Parts Manual

Series 90

55cc Axial Piston Pump

Service bulletin

Servo arm change

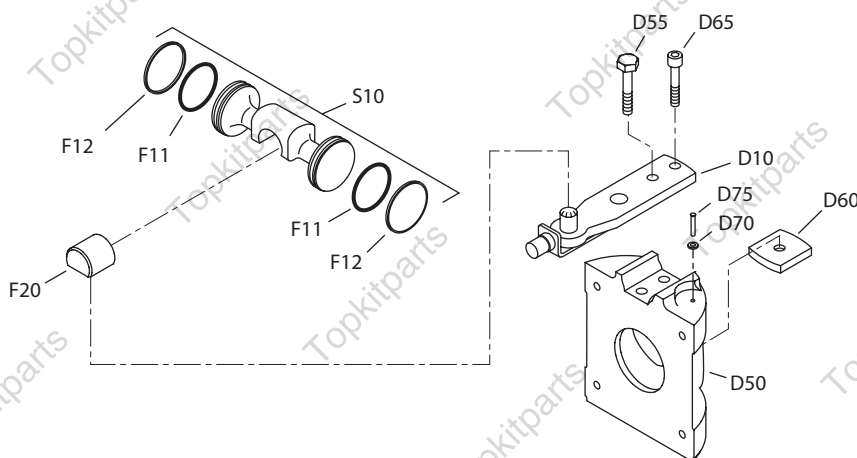
As a product improvement, Sauer-Danfoss has changed the series 90 pump servo arm and swashplate (item D10 and D50). The old style servo arm and swashplate will become obsolete. Because this change creates non-interchangeability between new and old swashplates, servo arms, and possibly servo piston (item S10) and slider block (item F20), separate servo arms and swashplates will no longer be sold as service parts.

Also, the new servo arm is actually a press fit into a groove in the new swashplate. This situation requires special tooling for assembly, therefore, pre-assembled kits will be created for 55, 75, and 100 cc pumps. The kits will work in any vintage pump.

The kit for 55 cc pumps will include all the items in the figure, except item S10

Change goes into effect with s/n 88-14-xxxxx on 55 cc pumps and with s/n 88-16-xxxxx for 75 cc and 100 cc pumps.

Subject Change to fixed clearance slipper hold down

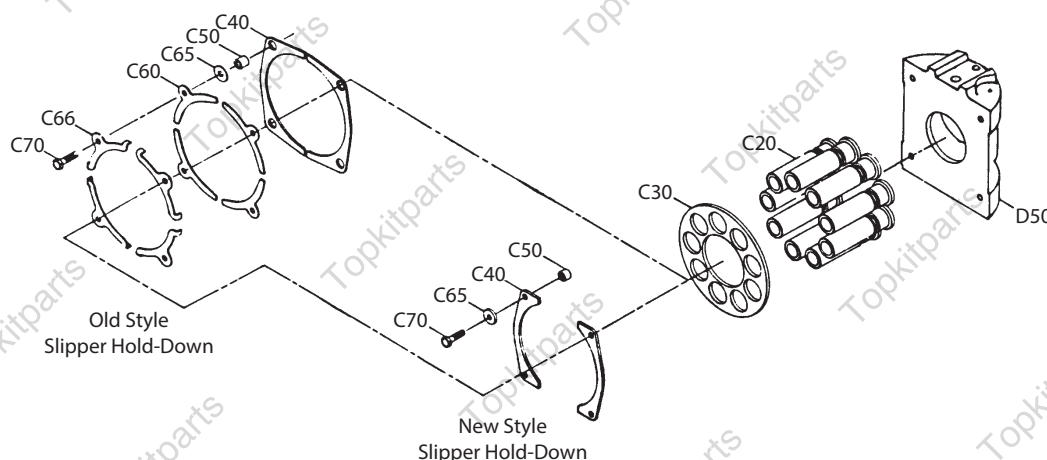
Description As a product improvement, Sauer-Danfoss has simplified the design of the series 90 pump slipper hold down mechanism. The hold down changes from spring loaded with a fixed maximum clearance design.

The leaf spring (item C60) and spring aligner (item C66) will be eliminated and will not be available as service parts.

The spacer (item C50), bearing (item C40), and washer (item C65) will change and the old part numbers will not be available as service parts.

Service Bulletin: SB-1988-024

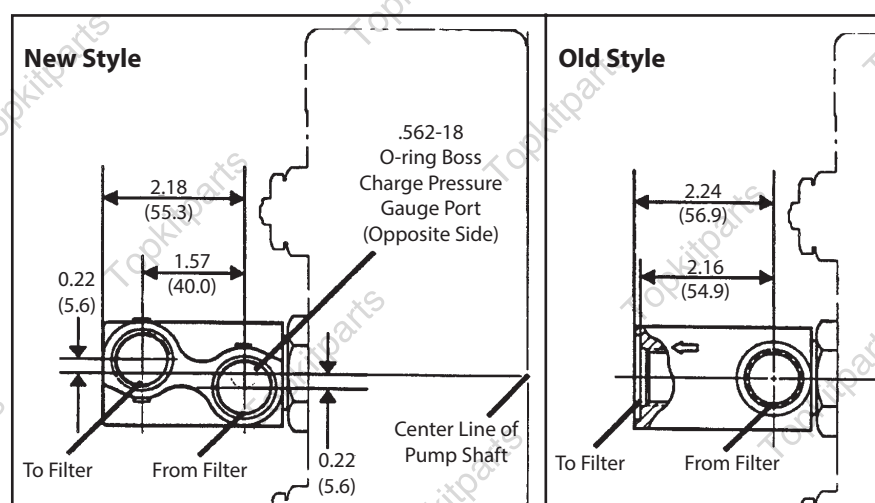
Subject Remote pressure filtration adapter change

Description The configuration of the remote pressure filtration adapter, available as an option on Sauer-Danfoss series 90 variable pumps (55, 75, and 100 cc) is changing. This improved design adapter incorporates a charge pressure test port. In addition, the remote filter connections have been relocated to improve the customer interface and the routing for filter plumbing on most applications. Port sizes did not change. (A version of the improved design adapter is already being used on Series 90 42 cc variable pumps.)

This change does not affect the pump end cap, and either design filtration adapter can be used on any vintage pump. Only the new style adapter will be available as service parts or on new production pumps.

Charge pump design change

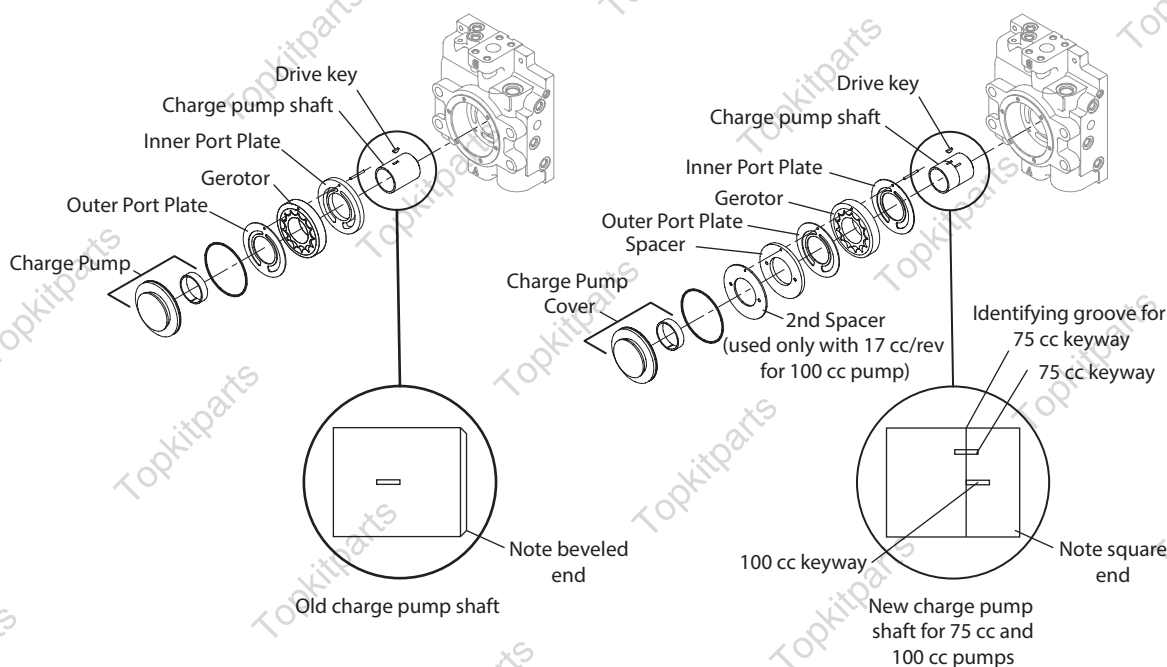
Parts disposition	■ Non-interchangeable - must use correct charge pump shaft per serial number of pump

Change takes place at serial number A-89-17-xxxxx.

Service Bulletin: SB-1989-037

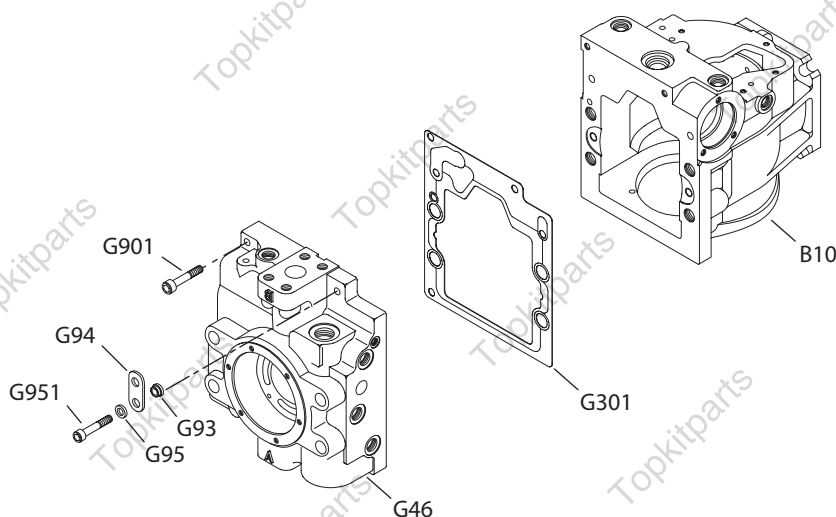
Subject End cap and housing change

Serial numbers Change takes place at serial number A-89-47-xxxxx.

Service Bulletin: SB-1992-011

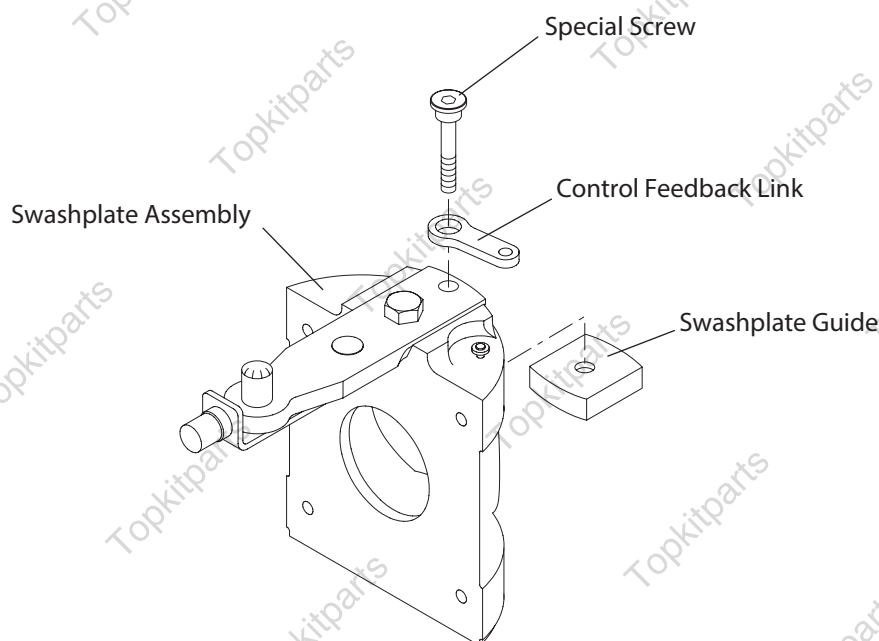
Description Effective in September of 1992, the feedback link in series 90 pumps will be mechanically retained to the swashplate. In the past, the link slipped over a specially ground socket head screw and could fall off the screw during assembly. The screw has changed to include a head to retain the link. The feedback link does not change.

Subject Charge pump design change

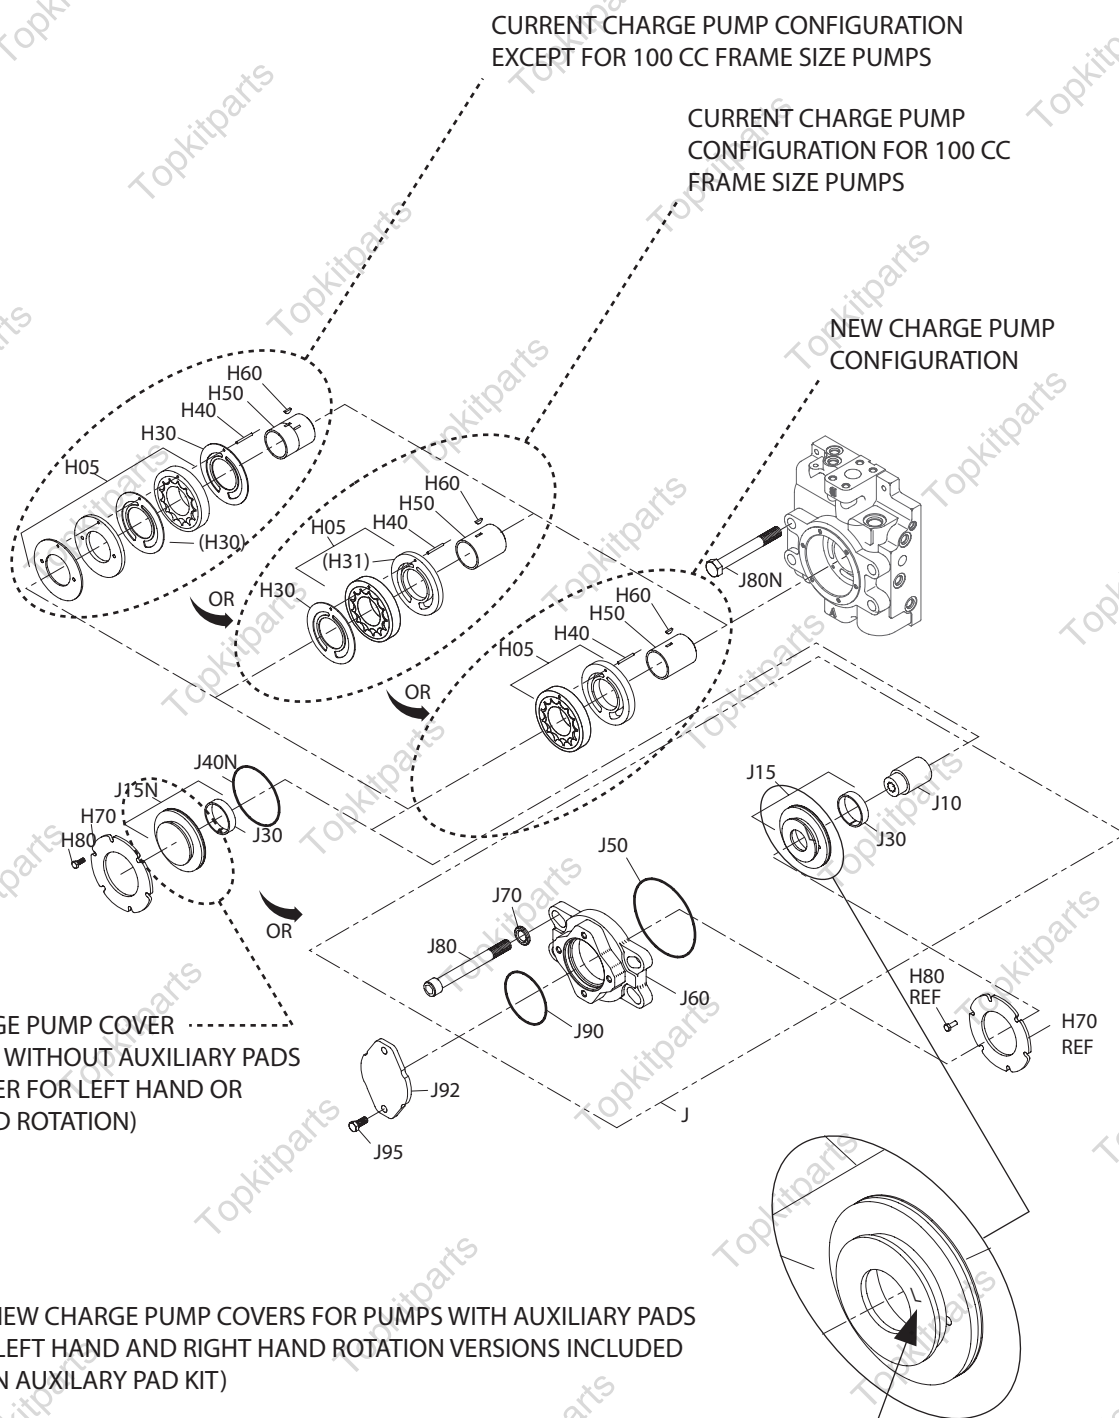
CURRENT CHARGE PUMP CONFIGURATION
EXCEPT FOR 100 CC FRAME SIZE PUMPS

CURRENT CHARGE PUMP
CONFIGURATION FOR 100 CC
FRAME SIZE PUMPS

NEW CHARGE PUMP
CONFIGURATION

Swashplate cage locator

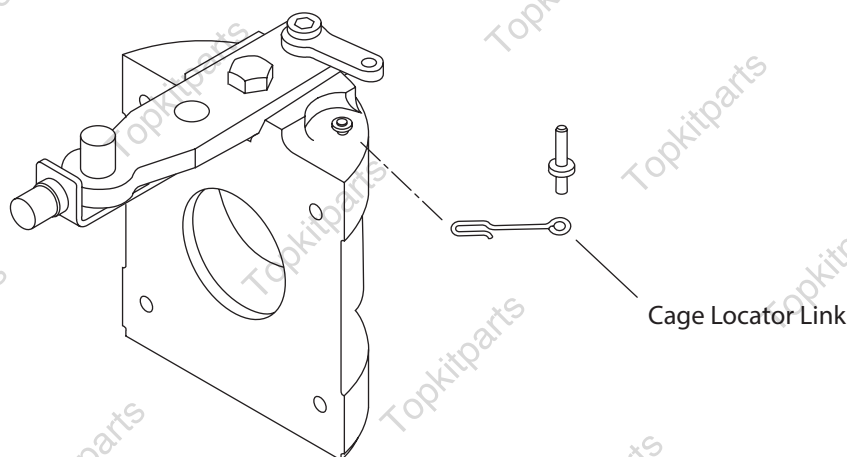
As a product improvement, Sauer-Danfoss has made a design change to the cage locator link used on the 55 thru 100 cc variable pumps.

The new link is made from square wire. In the past, the link was made from round wire. This is an interchangeable change.

Side cover washer elimination

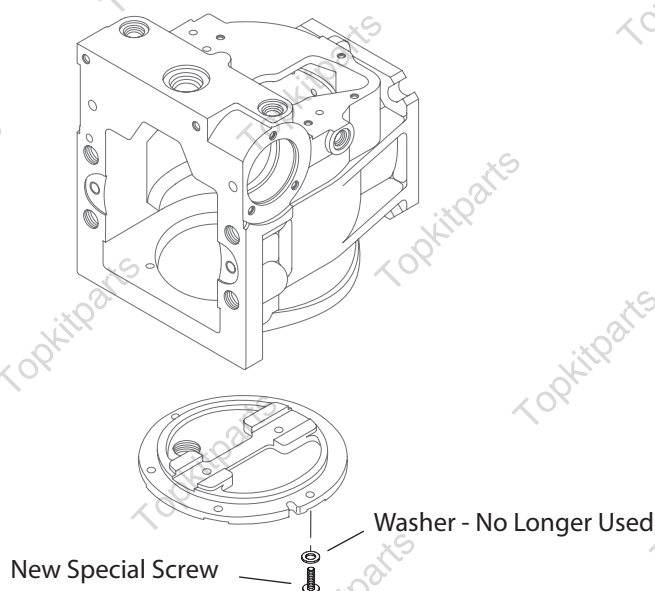
Change took place during the 2nd and 3rd quarter of 1994

Integral filtration manifold

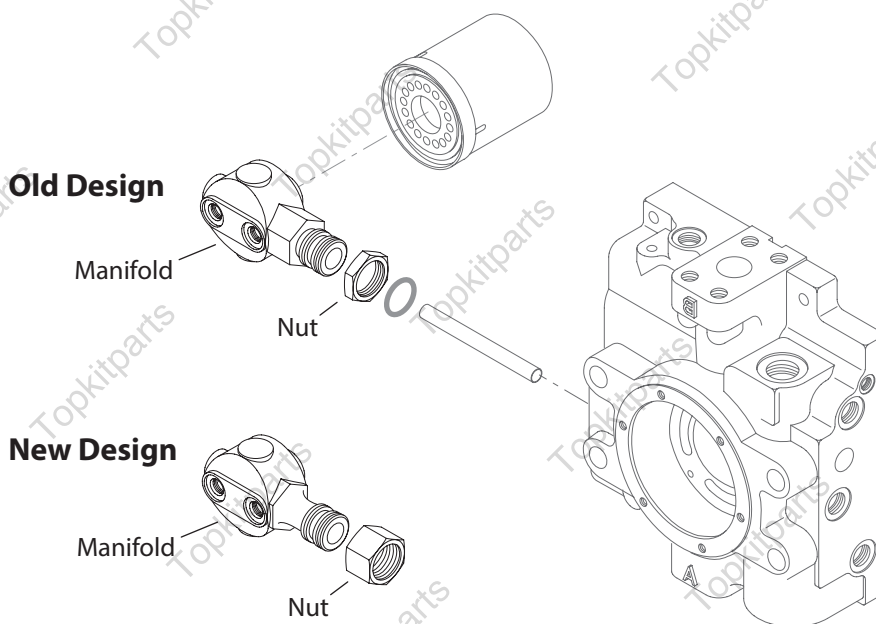
Change occurred at serial number 95-18-xxxxx

Service Bulletin: SB-1998-018

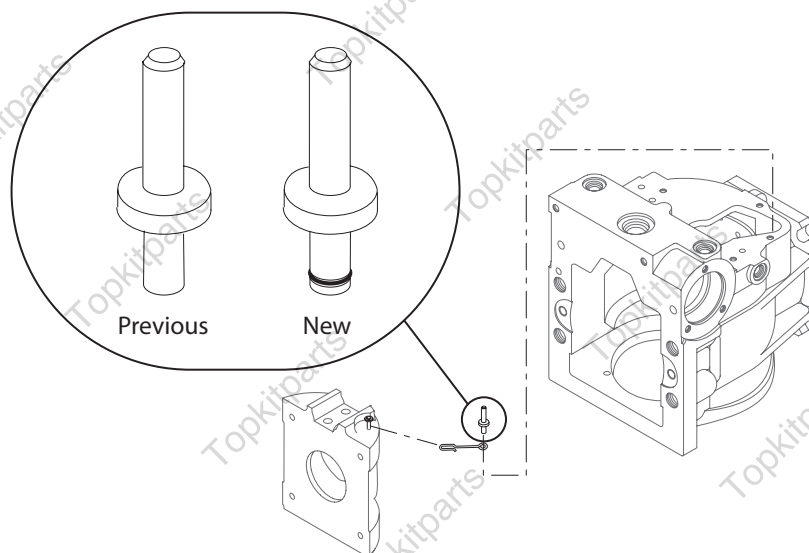
Description Sauer-Danfoss has modified the design of the swashplate bearing cage locator pin used in the series 90 55, 75, and 100 cc variable displacement pumps.

To aid in identifying this change, Sauer-Danfoss has released a new part number for the updated pin design. The new pin is completely interchangeable with the previous pin part number. The previous pin has been obsoleted.

Serial numbers This change became effective at serial number 98-24-xxxxx

Charge pump shaft part number change

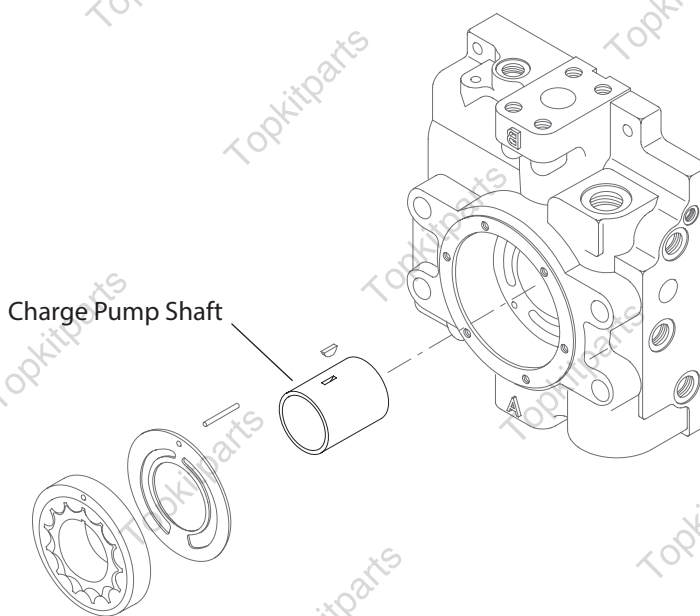
As a product improvement, Sauer-Danfoss has modified the design of the charge pump shaft used in series 90 55, 75 and 100 cc pumps. This change affects all charge pump sizes (11, 14, 17, 20, 26, and 31 cc) available in the series 90 displacement range.

The design modification includes a surface finish change to the charge pump shaft which improves the wear characteristics between the charge pump shaft and the journal bearings in the charge pump cover and end cap.

To assist in identifying this change, Sauer-Danfoss has released new charge pump shaft part numbers. The new shafts are completely interchangeable with the previous shafts. The new shaft has replaced the previous shaft in new pump assemblies and charge pump service kits. The previous shafts have been obsoleted and are no longer available as a service part. The chart on the next page will assist you in determining the part number changes.

Service Bulletin: SB-2005-011

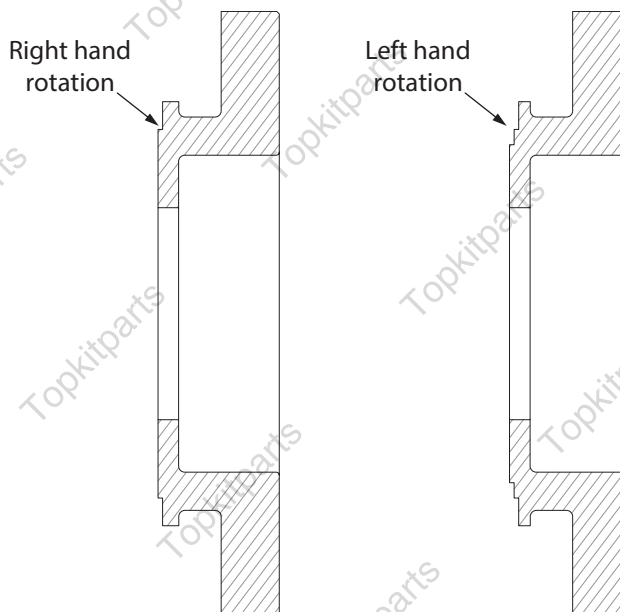
Subject Auxiliary flange charge pump cover

The part numbers of the charge pump covers will not change.

Serial numbers This change became effective at serial number A-05-17-xxxxx

Subject SAE B auxiliary mounting flange

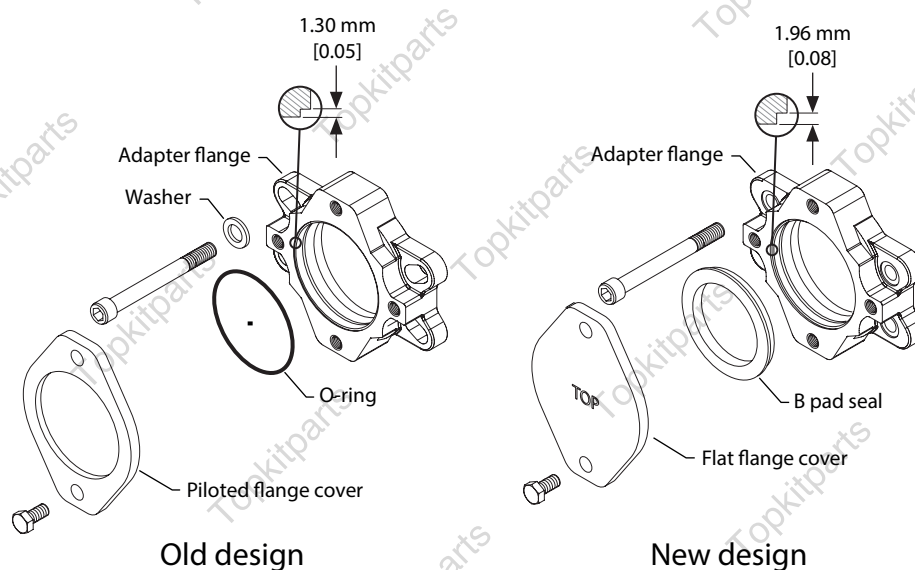
Part numbers affected Sauer-Danfoss is pleased to announce a design improvement on the SAE B auxiliary mounting flange adapter on its series 90 pumps. The frame sizes affected by this change are 55, 75, and 100cc. All manufacturing locations producing these pumps will be changed to this configuration.

The improvement comes in the form of a more robust sealing geometry with a larger cross-section O-ring. The O-ring groove in the flange will now be sized to mate with a 2.62mm [0.103] cross section O-ring rather than the old 1.78mm [0.070] cross-section O-ring. The Sauer-Danfoss part number for the new O-ring is 9004104-1540 (2.62mm [0.103] x 94.92mm [3.737]). The larger cross-section sealing geometry allows for the use of a donut style B pad seal and a new flat cover for improved assembly. This new configuration is qualified as a running cover. When installing an auxiliary pump, the donut style B pad seal must be discarded and part number 9004104-1540 O-ring used.

Also, the flanges will no longer have a slotted interface with a washer for the end cap screws. The flanges will now have round through holes for the end cap screws and will use no washers. The end cap screws do not change. This eliminates the area where water or high pressure wash chemicals can be trapped around the end cap screws. There now are specific part numbers for the flanges used on each of the three displacement size pumps; 55, 75 and 100 cc.

The pumps will now be supplied with the donut style seal and new flat cover, instead of the small O-ring and cover plate (shown in the drawing below).

Serial numbers This change became affective at serial number; A 08-19-xxxxx.
